1. Letter Re: Duplex Proposal
- 2.
- 3.
- 4.

August 5, 1997

RE: Proposal for Two Duplexes, Stevenson, WA

ENC: Site Plan Sketch
Duplex Drawings

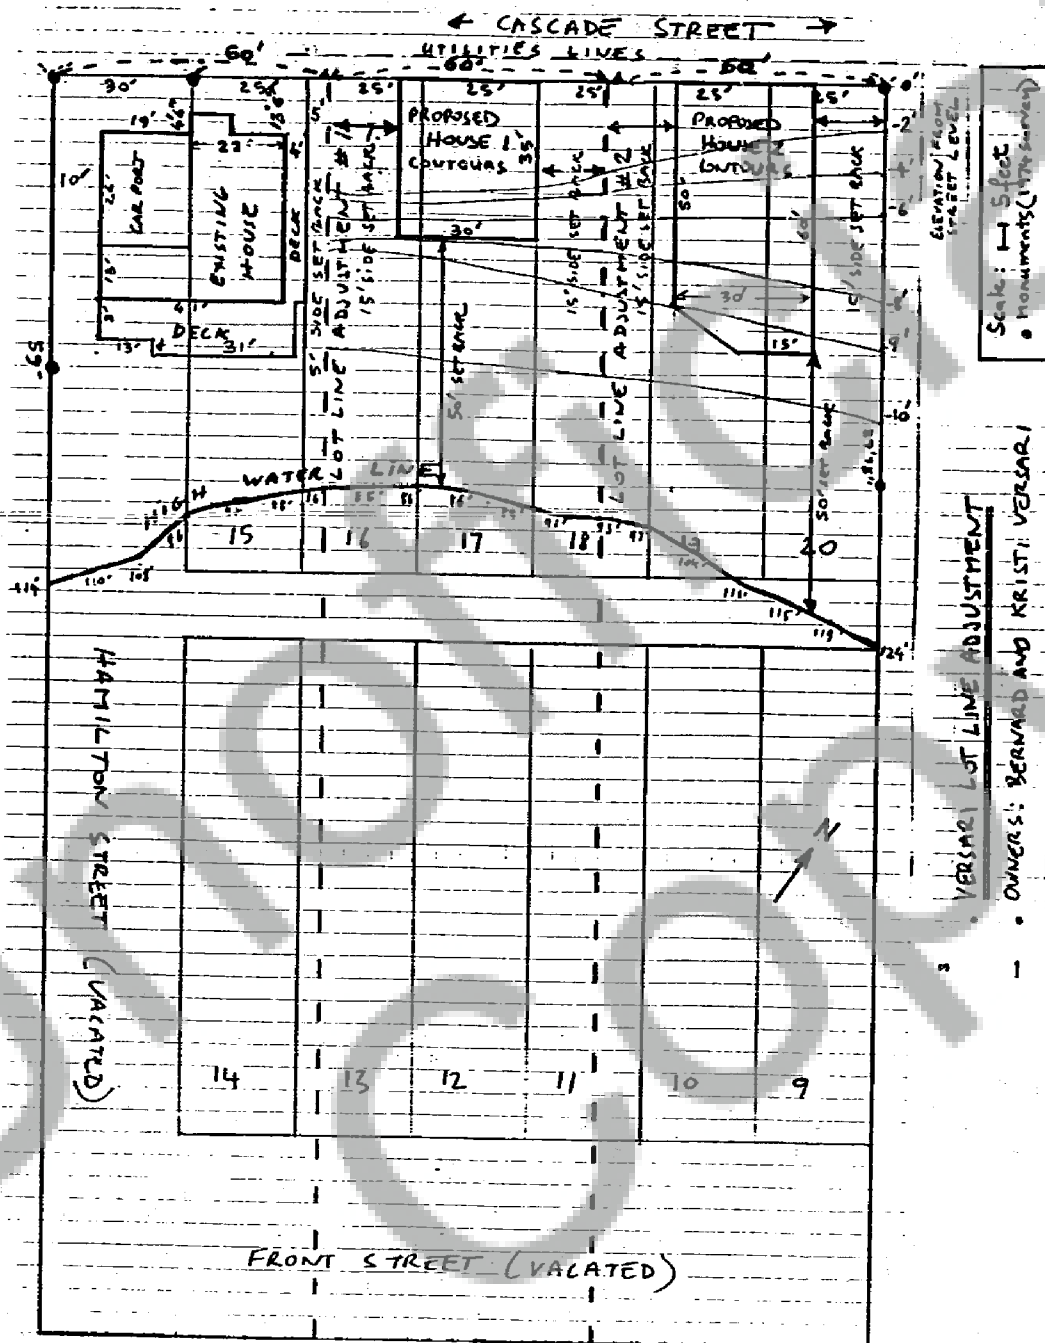
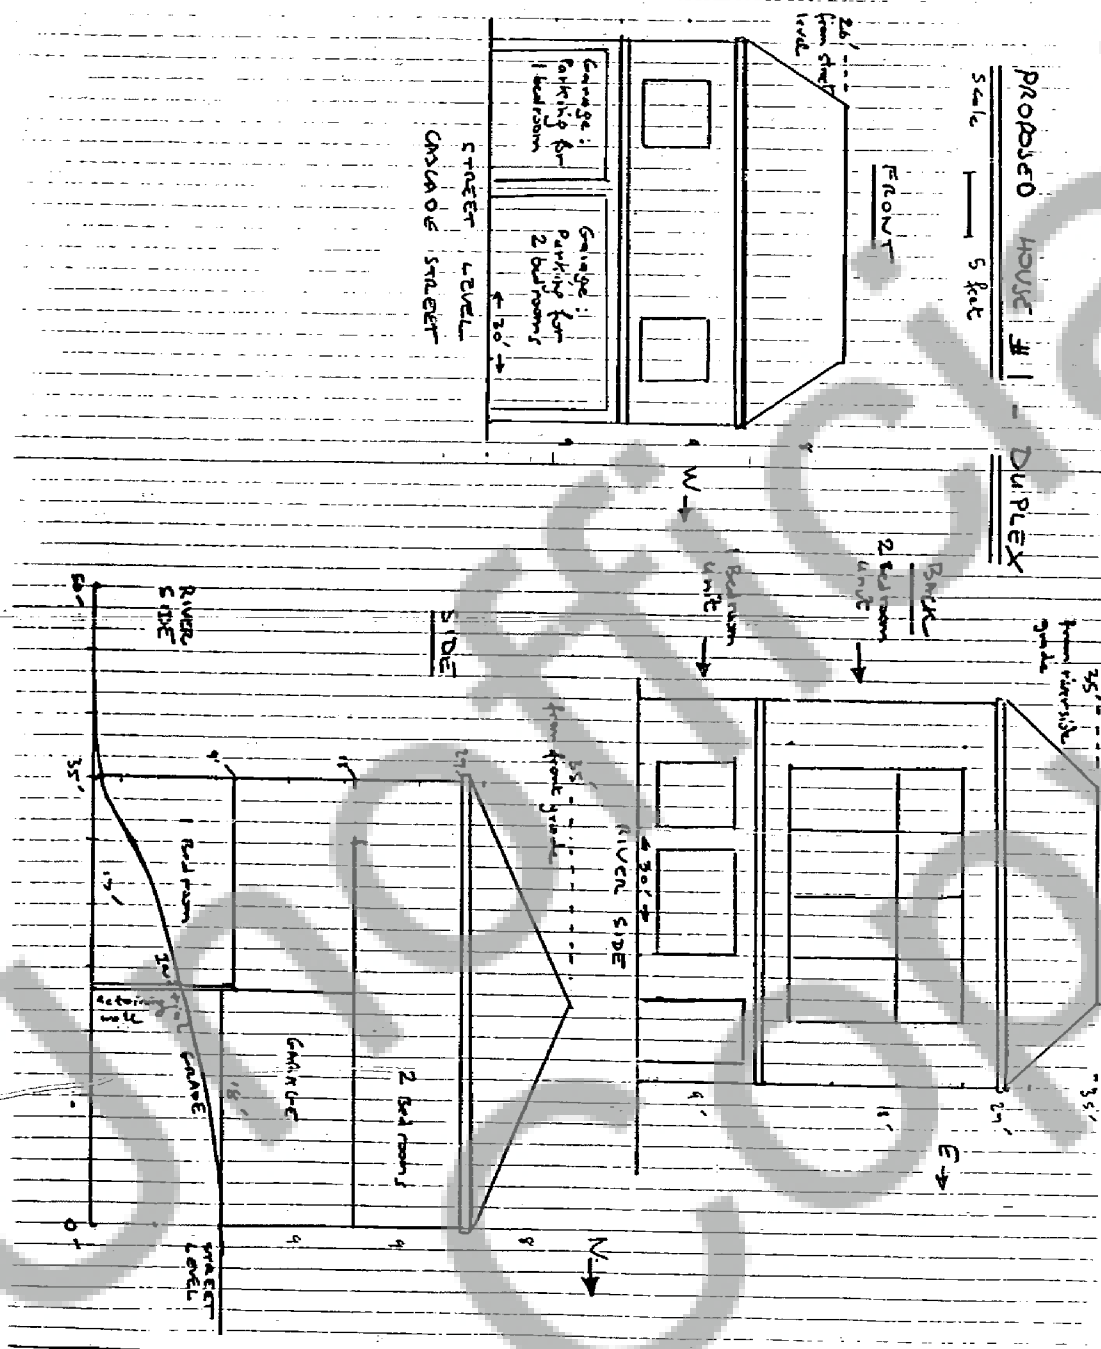
Your sketch plans for a duplex on Parcel II and a duplex on Parcel I appear to meet the general requirements of city zoning and shoreline regulations. The C1 zone would allow for the duplex uses and zero setbacks for building along Cascade Avenue. (Single-family construction would require a setback of 15 feet). On-site parking for the duplexes would have to be provided.

Shoreline regulations require a building setback of 50 feet from the ordinary high water mark, measured at a right angle to the shoreline. (Proposed building No. 2 on Parcel I, as shown on the drawing, may be too close to the shoreline but could easily be revised). The side yard setbacks for each building would have to be 15 feet from the lot lines, as shown. Maximum building height would be 35 feet from average grade. Shoreline regulations do not allow parking within the front yard or sideyards. Parking within the building, as shown on the drawings, is an acceptable solution.
